**Replacement Requirements for Components of the LED Matrix Main Headlights: No Mixed Installation of Component Parts is Permitted (25/24)**

Model Line: **Taycan (Y1A / Y1B / Y1C)**

Concerns: **Headlight and LED light source control unit (matrix module)**

*Installation position of the headlight control unit and LED light source*

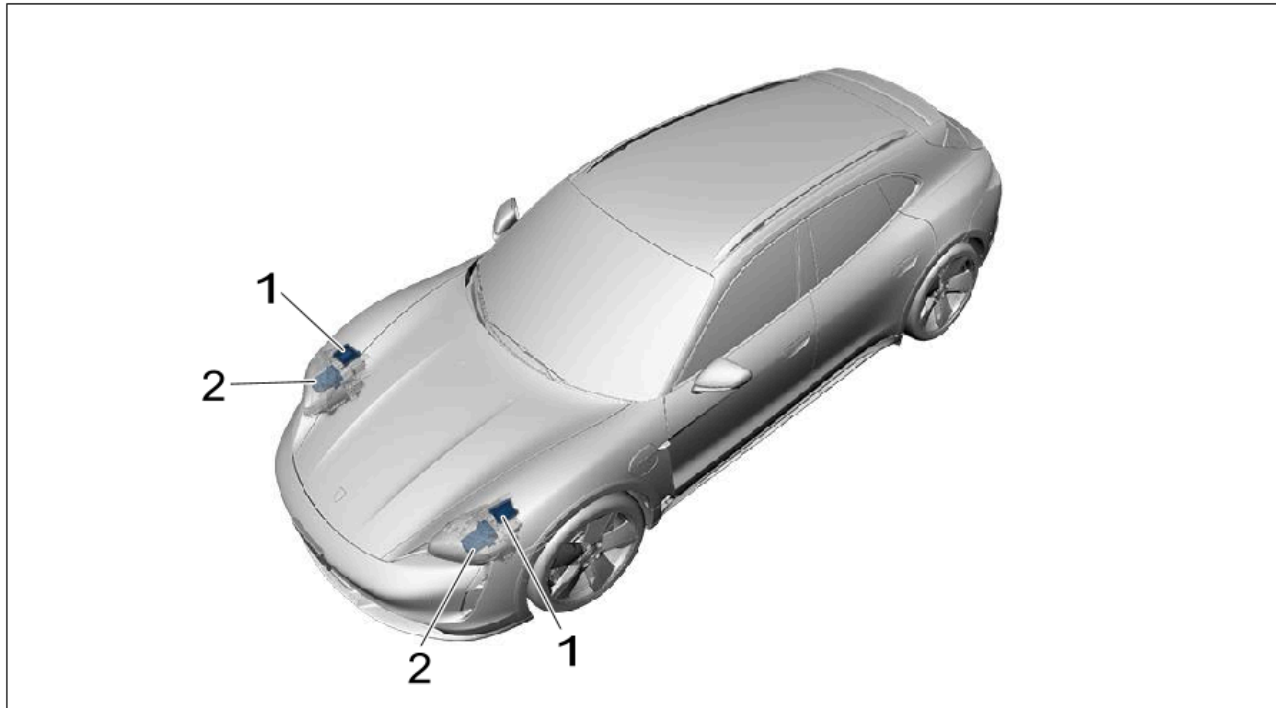
Cause: **Different component levels are available for the headlight control unit and the LED light source (matrix module) in the event of a replacement requirement. The previous component levels are not compatible with the new component statuses.**

Action: Determine the components required for a replacement using the table in the section ⇒ *Technical Information 'overview for permissible combinations and options'*, and depending on the determined need for replacement, replace the defective **components** or **replace both previous components (headlight control unit and LED light sources) with the new component level.**

The part number of the installed LED matrix module cannot be determined directly. Since the LED light source (matrix module) 9J1941661 is compatible only with the headlight control unit index .BA and the LED light source (matrix module) 9J1941661A is compatible only with the headlight index control unit .BG, the headlight control unit can be used to trace back to the installed LED light source (matrix module).

Combination	Replacement requirement component	Availability of parts	Procedure
1.	Headlight control unit <b>992941592BA</b>	Headlight control unit <b>992941592BA</b> <b>Available</b> in the warehouse.	Replace headlight control unit 992941592BA.

2.		Headlight control unit <b>992941592BA</b> <b>Not available</b> in the warehouse.	<b>Replace headlight control unit and LED light source (matrix module) in the main headlight with the new component level:</b> <b>Headlight control unit 992941592BG</b> and additionally install <b>LED light source (matrix module) 9J1941661A</b> .

3.	Headlight control unit <b>992941592BG</b>	Headlight control unit <b>992941592BG</b> <b>Available</b> in the warehouse.	Replace control unit 992941592BG for headlights.

4.	LED light source (matrix module) <b>9J1941661</b>	LED light source (matrix module) <b>9J1941661</b> <b>Available</b> in the warehouse.	Replace LED light source (matrix module) 9J1941661

5.		LED light source (matrix module) <b>9J1941661</b> <b>Not available</b> in the warehouse.	<b>Replace LED light source (matrix module) and headlight control unit in the main headlight with the new component status:</b> <b>LED light source (matrix module) 9J1941661A</b> and additionally install <b>Headlight control unit 992941592BG</b> .

6.	LED light source (matrix module) <b>9J1941661A</b>	LED light source (matrix module) <b>9J1941661A</b> <b>Available</b> in the warehouse.	Replace LED light source (matrix module) 9J1941661A.
